Elizabeth F. Napoli Deputy Director GHURA-01-27-2022-AMPs 1, 2, 3 & 4

Renovation of Seven (7) Public Housing Units at AMPs 1, 2, 3 & 4 **ADDENDUM NO. 1**

February 16, 2022

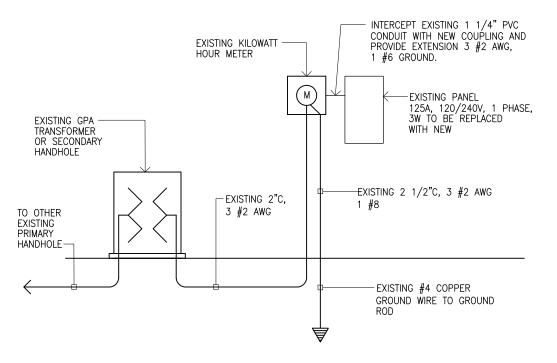
B. Relocate panel box to interior of unit and perform electrical upgrade on unit per attached specifications.

EXISTING RECEPTACLE TO BE PROVIDED WITH WEATHERPROOF COVER. NEW CIRCUIT BREAKERS SHALL BE GFC1 TYPE.

INSTALL NEW DRYER OUTLET COMPLETE WITH WIRING

EXISTING EXTERIOR PANEL & ENCLOSURE TO BE PROVIDE & INSTALL NEW PANEL OPPOSITE THE EXISTING. SEE DETAIL.

EXISTING TELEPHONE & CABLE TV CABINET TO BE PROVIDED WITH NEW COVER ONLY.
